Memorandum

To: MPO Policy Board
From: Sandy Shackelford, Director of Planning & Transportation
Date: June 14, 2021
Reference: Smart Scale Round 5 – CTAC Discussion Summary

CTAC Hydraulic Road/Route 29 Intersection Improvement:

CTAC Rivanna River Bicycle and Pedestrian Crossing:

Sheet 5 of 5 (elevated roadway deck shown)

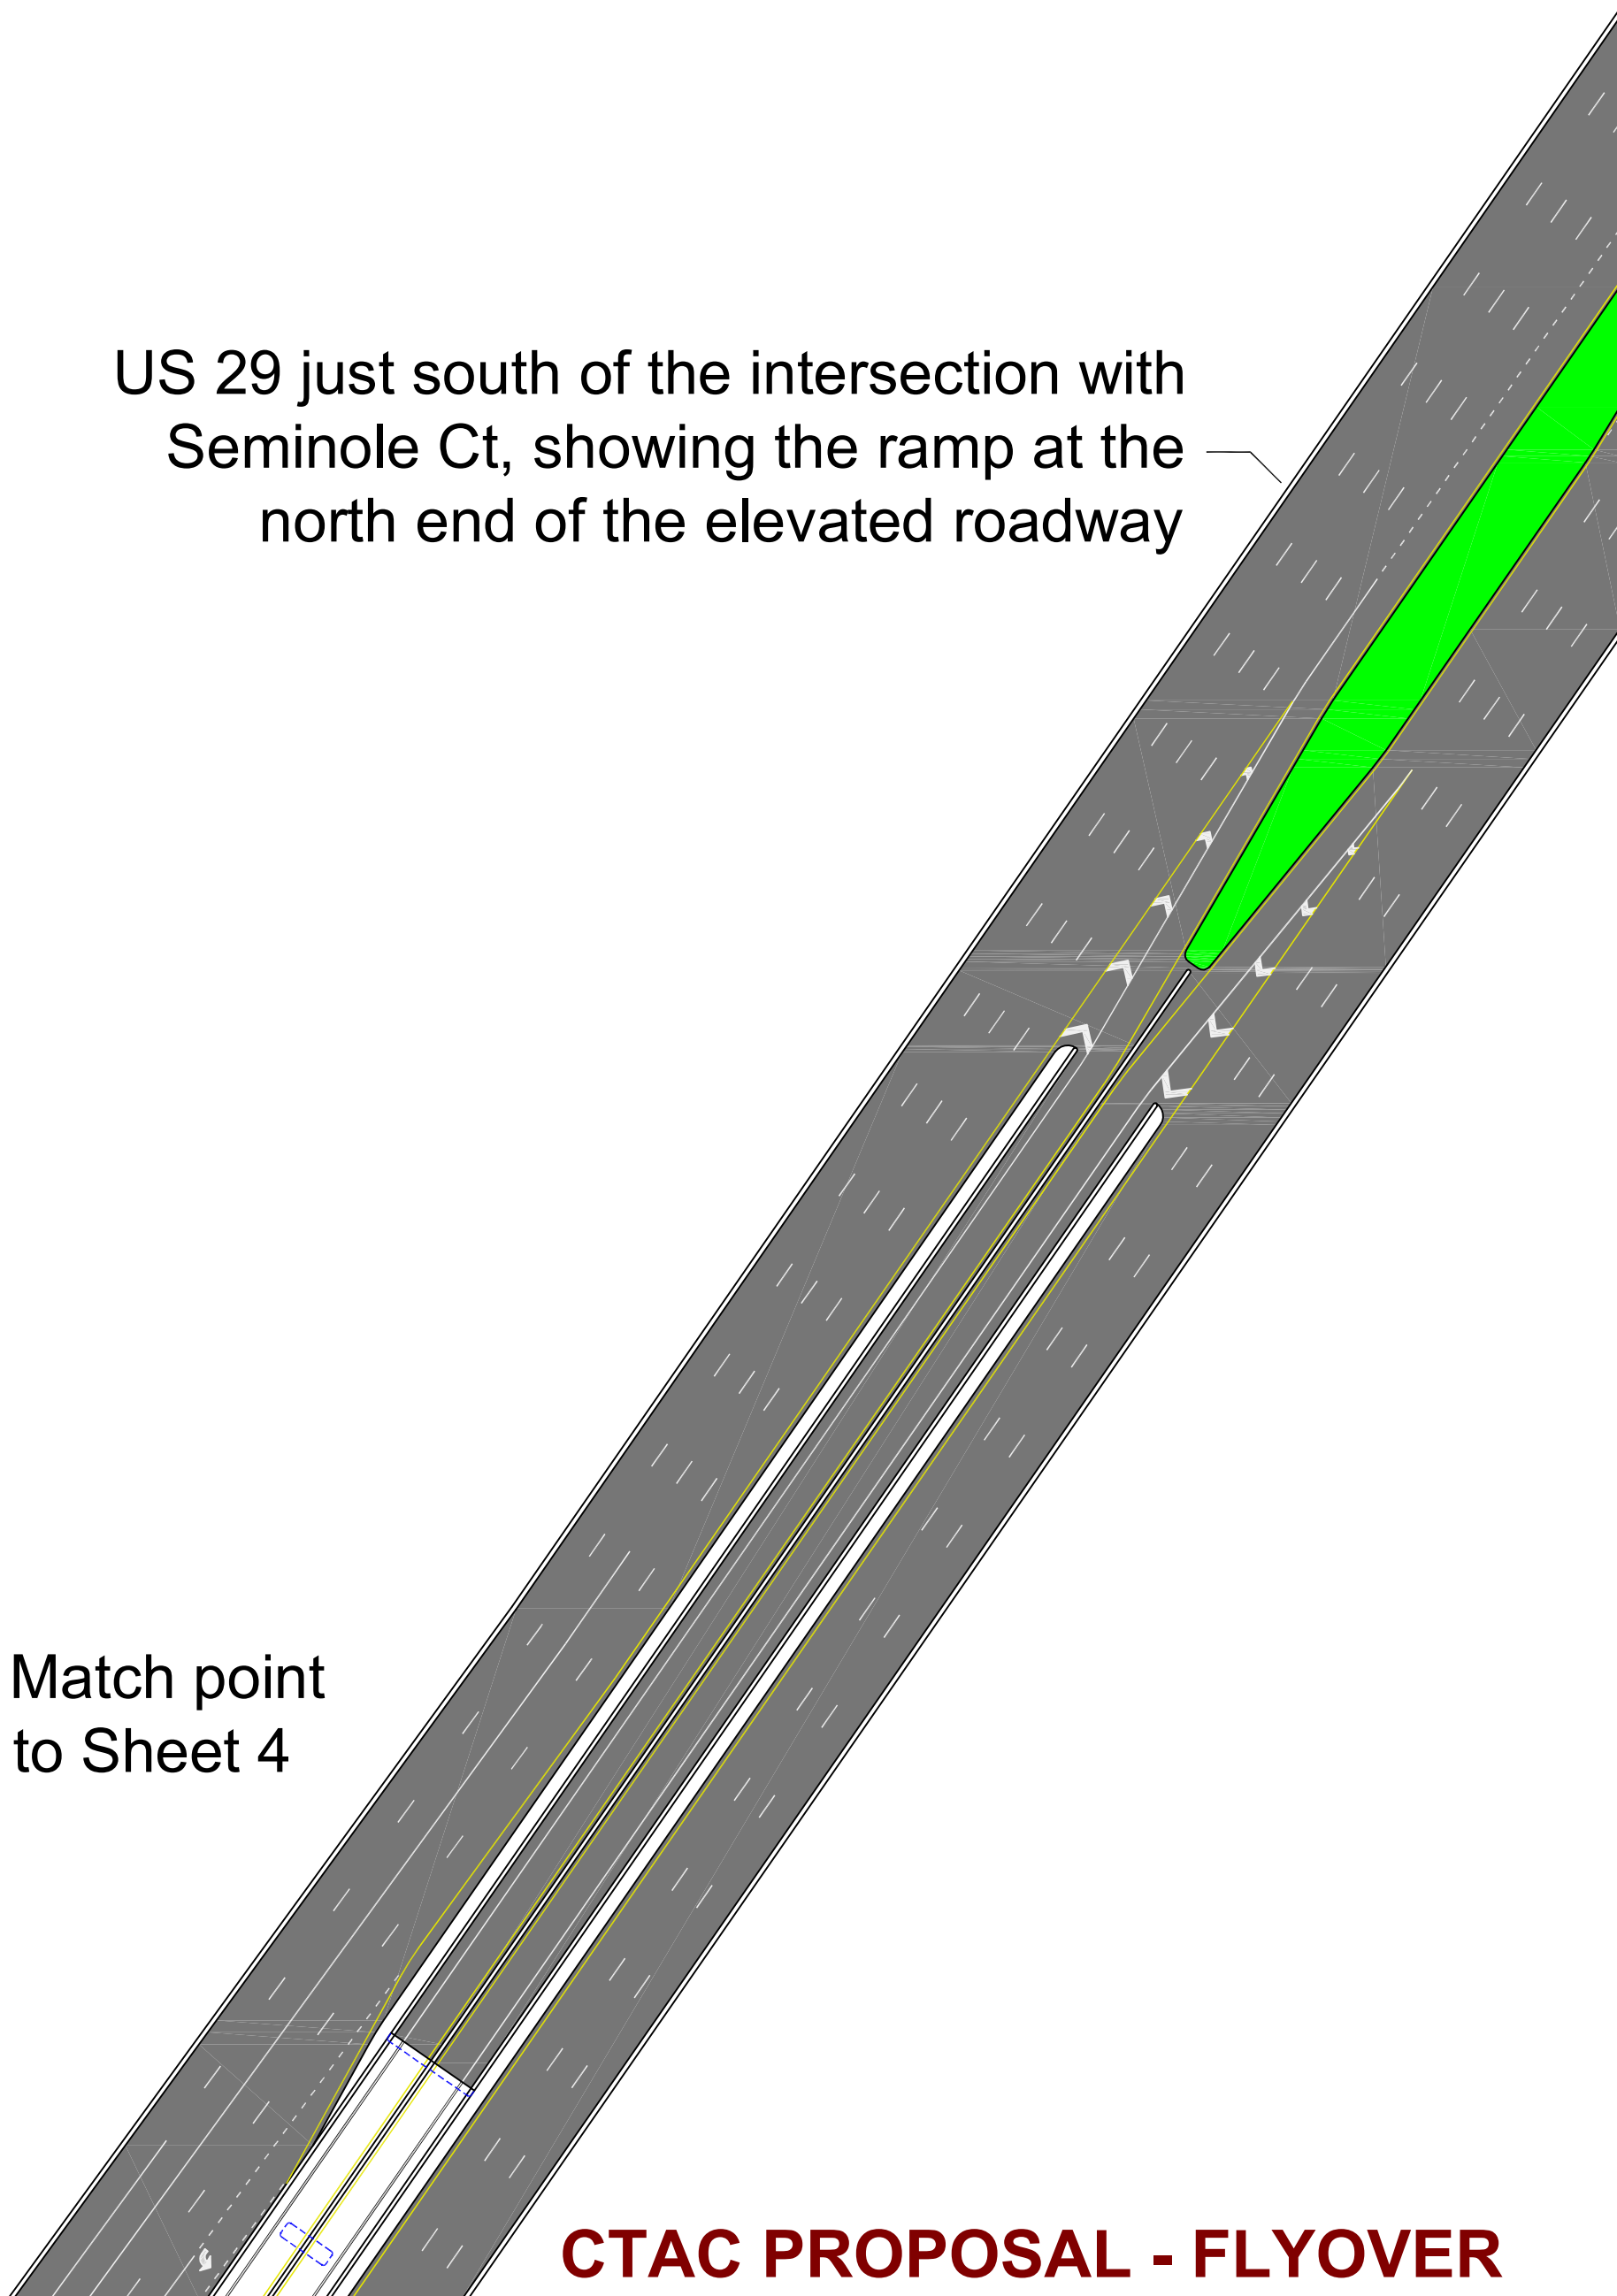
- Appreciation for the work Mr. Kondor put into developing the proposal.
- Concerns regarding the financial implications of pursuing this alternative intersection design considering the likely impacts to the Hydraulic/29 intersection improvements awarded in Round 4 and the loss of the Solutions 29 funding that was applied to that application.
- Concerns regarding the use of the 29 median to construct the proposed ramp and how that could limit future opportunities to potentially expand transit service along US 29.
- A desire to prioritize other projects that would support the development of multi-modal infrastructure.
- Concern that the proposed configuration would make pedestrian movements more challenging across US 29.
- Concerns regarding the safety of the ramp during adverse weather conditions.
- Concerns regarding the length of construction and impacts on local businesses.

- The proposed project would have congestion relief benefits by removing through traffic from the section of Emmett Street from Hydraulic Road South.
- It is unlikely that this project is eligible for funding since improvements to the Hydraulic Road/US 29 intersection were recommended for funding in SMART SCALE Round 4. To pursue this project, the MPO would have to decline the previous award and forego the \$18 million of Solutions 29 money that was allocated for congestion relief in the area prior to submitting this as an application. This application would replace the entirety of the previously awarded application, which includes the Hydraulic/29 intersection improvements, the Zan Road bike and pedestrian bridge, shared use paths along Hydraulic Road from Brandywine Drive to Michie Drive, and the roundabout at Hydraulic Road and Hillsdale Drive.

- The cost estimates have not been verified by VDOT staff, and it is possible that the estimated cost for the project would increase upon a VDOT review.

- The City of Charlottesville has extreme reservations about an elevated roadway/bridge system at this location within the City based on the initial costs as well as future maintenance, inspections, and eventual replacement expenses.
- A similar design was considered as part of the Solutions 29 Advisory Panel and was not recommended to move forward by the panel at the time that the final recommendations were developed.

No action is requested from the Policy Board at this time. CA-MPO staff will include the CTAC-proposed flyover concept to the list of potential projects for consideration by the Policy Board at their meeting on July 28, 2021. If there are any questions or comments, please contact Sandy Shackelford at sshackelford@tjpd.org.

RIVANNA RIVER BIKE/PED CROSSING	
KONDOR ENGINEERING	
05/01/2021	Scale: 50 FT =

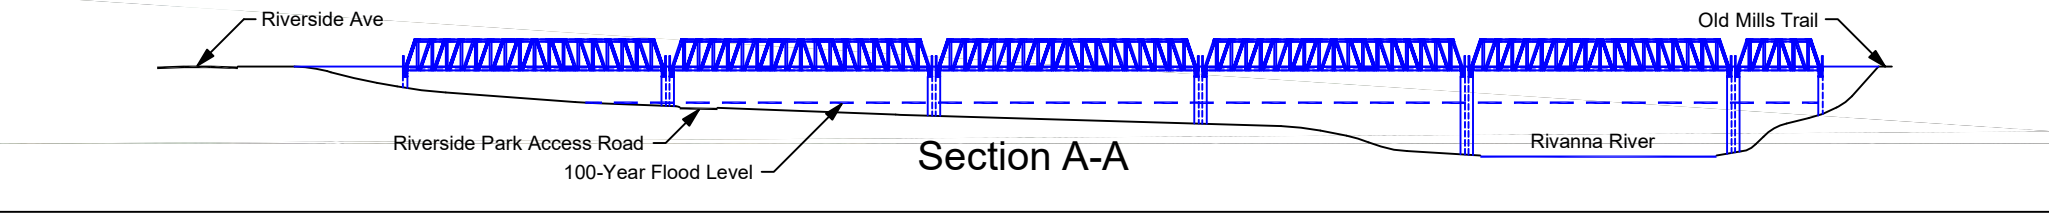
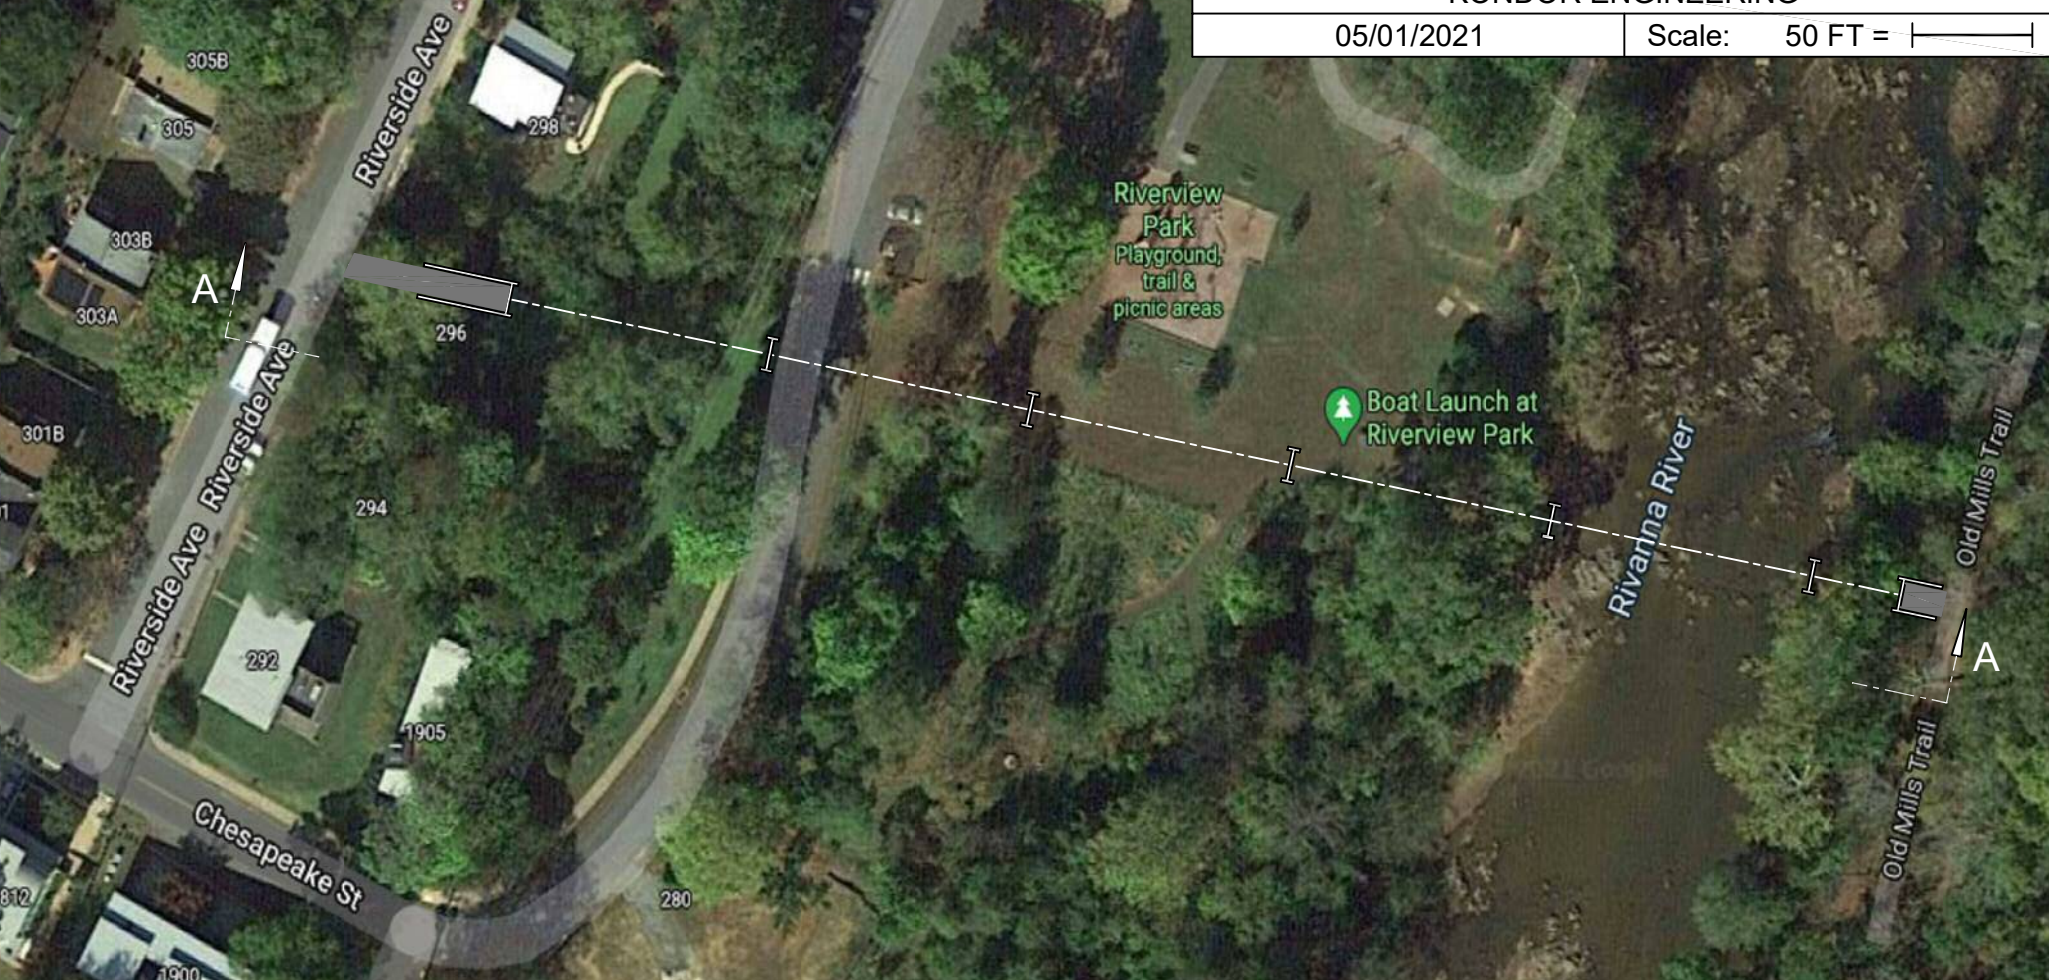
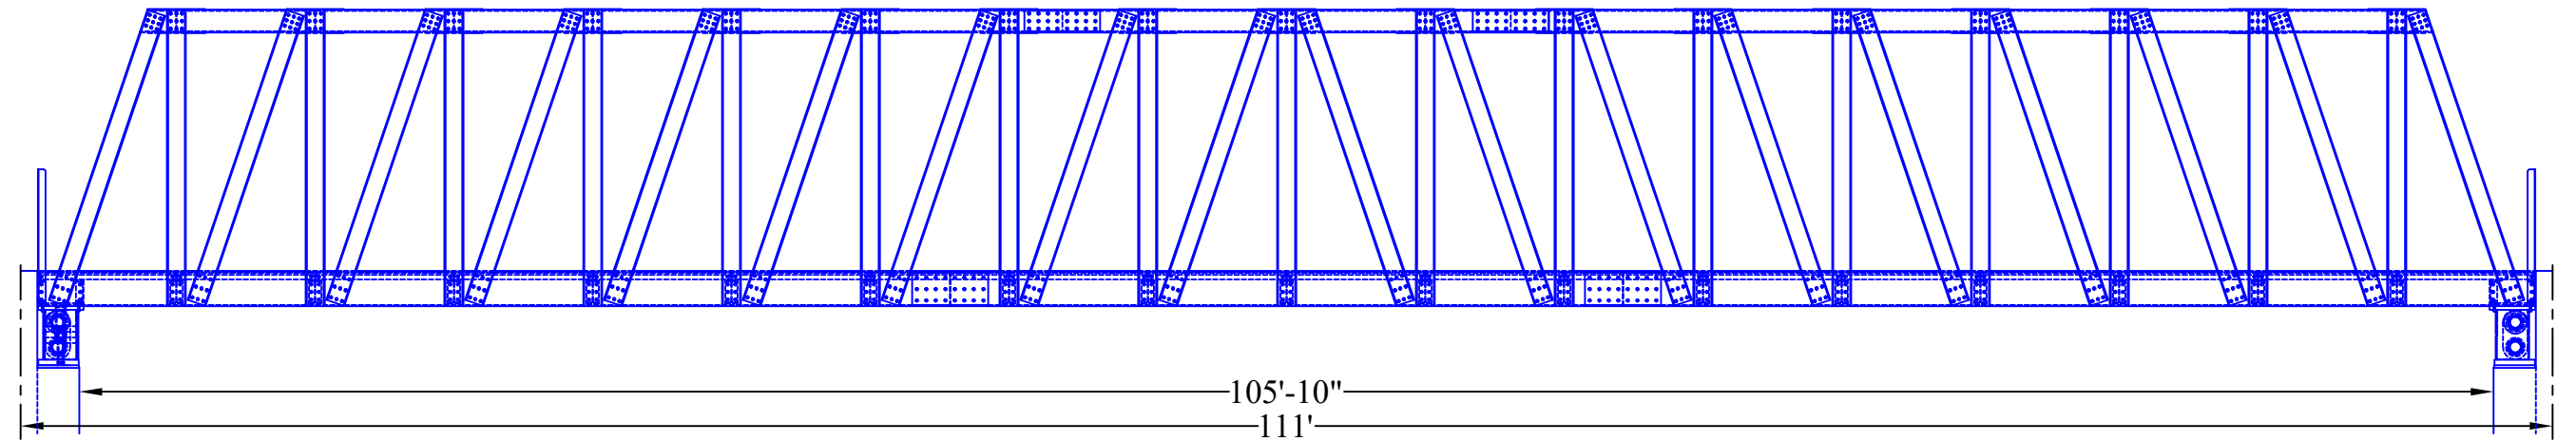
There was general support from CTAC for considering an option that would connect to Old Mills Trail, but CTAC members also expressed their desire that bicycle and pedestrian connectivity be prioritized beyond potential flooding impacts since the bridge would likely not be utilized by pedestrians during flood conditions.

There are a number of technical considerations that would need to be evaluated to develop a final application. The number of piers, impacts to the park, access, and connection to existing facilities will need to be evaluated.

Should the Policy Board select the Rivanna River Bicycle and Pedestrian Crossing as one of the projects they would like CA-MPO staff to pursue, a discussion of alternative design options, such as the one that is discussed here, could be considered as the final application is developed.
